7.6 All Other Instrumentation Systems Required for Safety

The information in this section of the reference ABWR DCD, including all subsections, tables, and figures, is incorporated by reference with the following departures and supplements.

Figure 7.6-4a Basic Configuration of a Typical Neutron Monitoring System Division

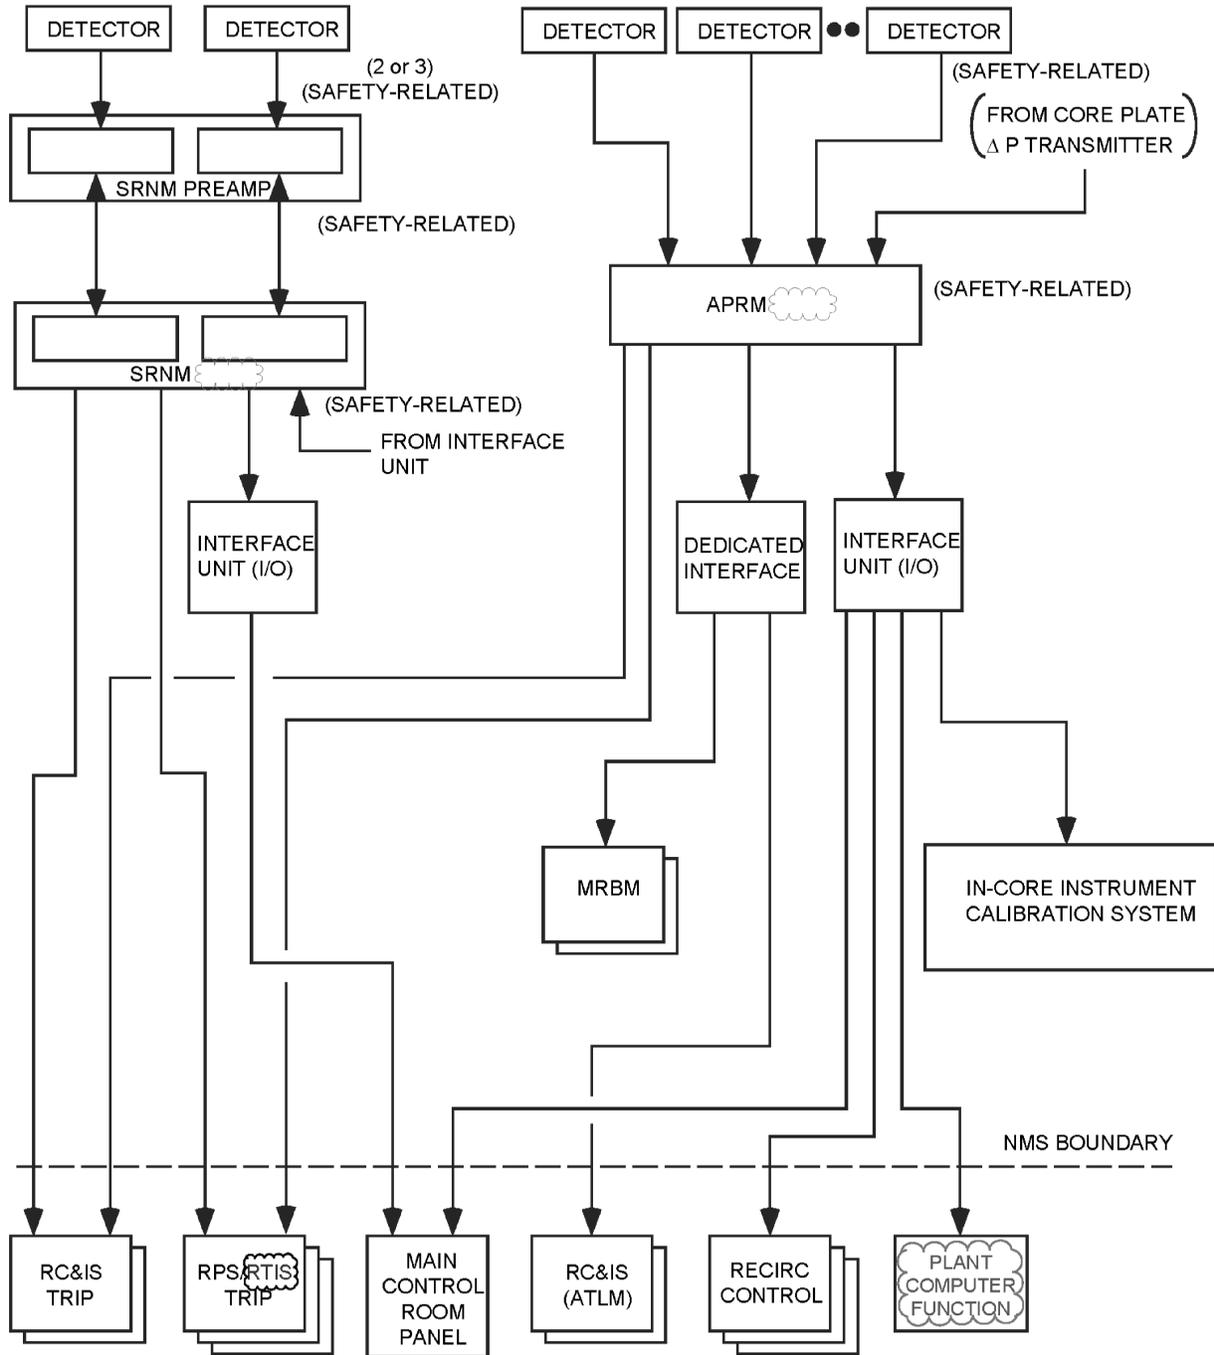
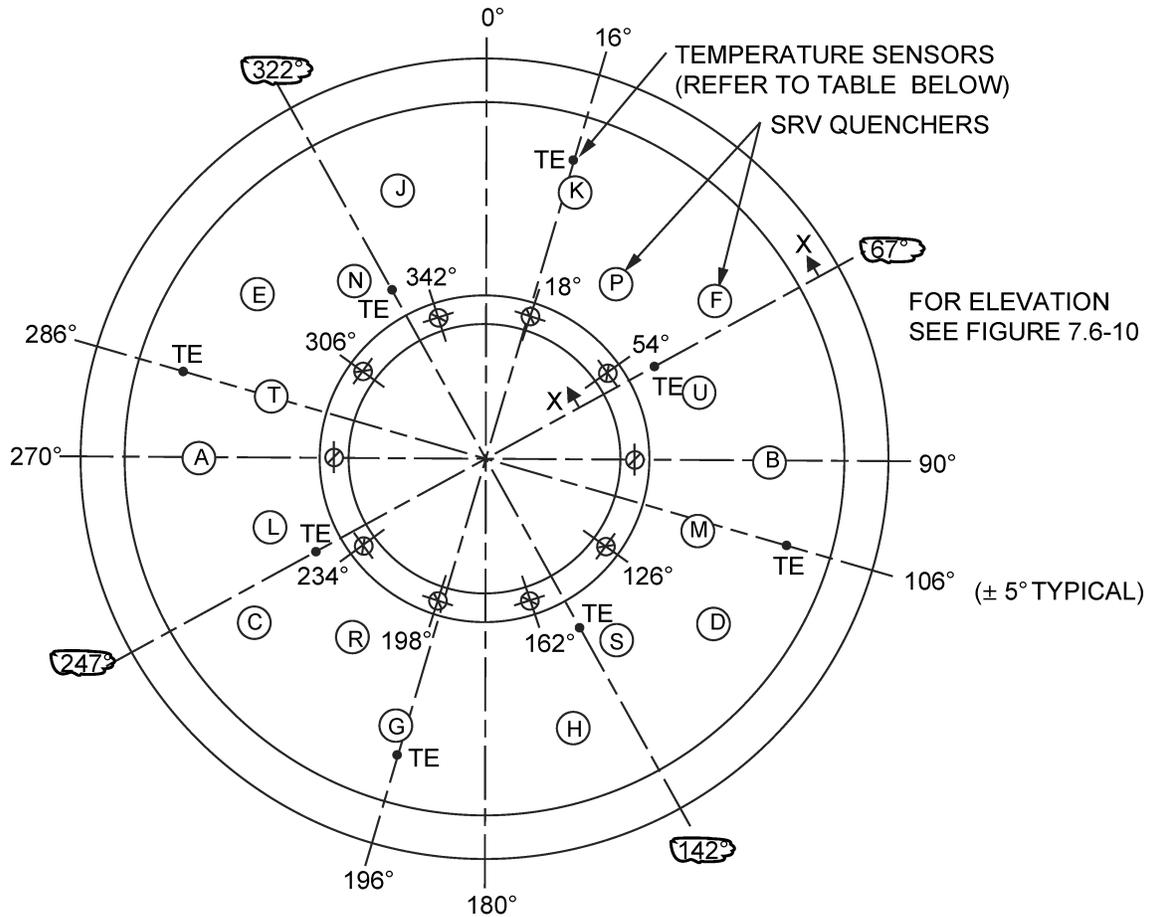
STD DEP T1 3.4-1 (Table 7.6-5 and Figures 7.6-1, 7.6-2, 7.6-4a)

STD DEP T1 3.4-1

The purpose of the Neutron Monitoring System (NMS) is to monitor power generation and, for the safety function part of the NMS, to provide trip signals to the Reactor Protection System (RPS) to initiate reactor scram under excessive neutron flux (and power) increase condition (high level) or neutron flux fast rising (short period) condition. The NMS also provides power information of operation and control of the reactor to the Plant Process Computer System (PCS) Functions (PCF) and the rod block monitor. A block diagram showing a typical NMS division is shown in Figure 7.6-4a. The operating ranges of the various detectors are shown in Figure 7.6-4b.

Figure 7.6-9 Instrumentation Location Definition for the Suppression Pool Temperature Monitoring System

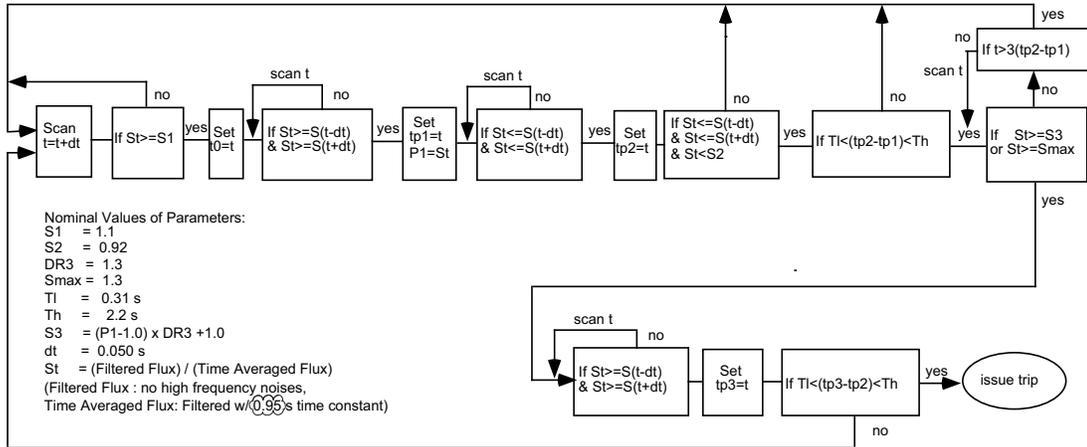
STD DEP 7.6-3 (Figures 7.6-9, 7.6-11)

The SPTM System configuration is shown in Figures 7.6-9 and 7.6-10. There are eight temperature circumferential sensor locations (Figure 7.6-9), which are chosen based upon the following considerations:

- (2) Each SRV discharge line quencher is in direct sight of two sets of temperature sensors within 9 meters.

Figure 7.6-14 OPRM Logic

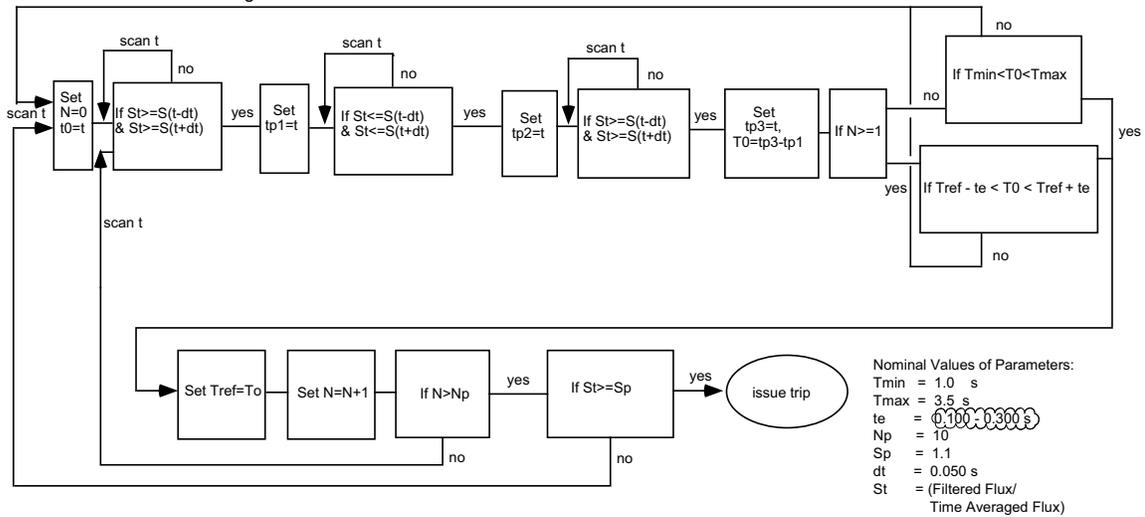
STD DEP 7.6-1 (Table 7.6-2 and Figures 7.6-2, 7.6-14)

~~For the OPRM trip function, the response signal of any one OPRM cell that satisfies the conditions and criteria of the trip algorithm will cause a trip of the associated OPRM channel. Figure 7.6-14 illustrates the trip algorithm logic. The OPRM trip function does not have its own inoperative trip for insufficient number of total LPRM inputs in the channel. It follows the APRM's inoperative trip of insufficient number of LPRMs.~~ The OPRM function has its own inoperative trip when the channel has less than the required minimum operable cells, when there is an OPRM self-diagnostic fault, when the APRM instrument watchdog timer has timed out, or if there is a loss of power to the APRM instrument.

$T_{\min}=1$ s, $T_{\max}=3.5$ s, $\pm t_{\text{error}}=0.15$ s **[0.100 - 0.300s]**, $N_P=10$.
(For details see Figure 7.6-14).
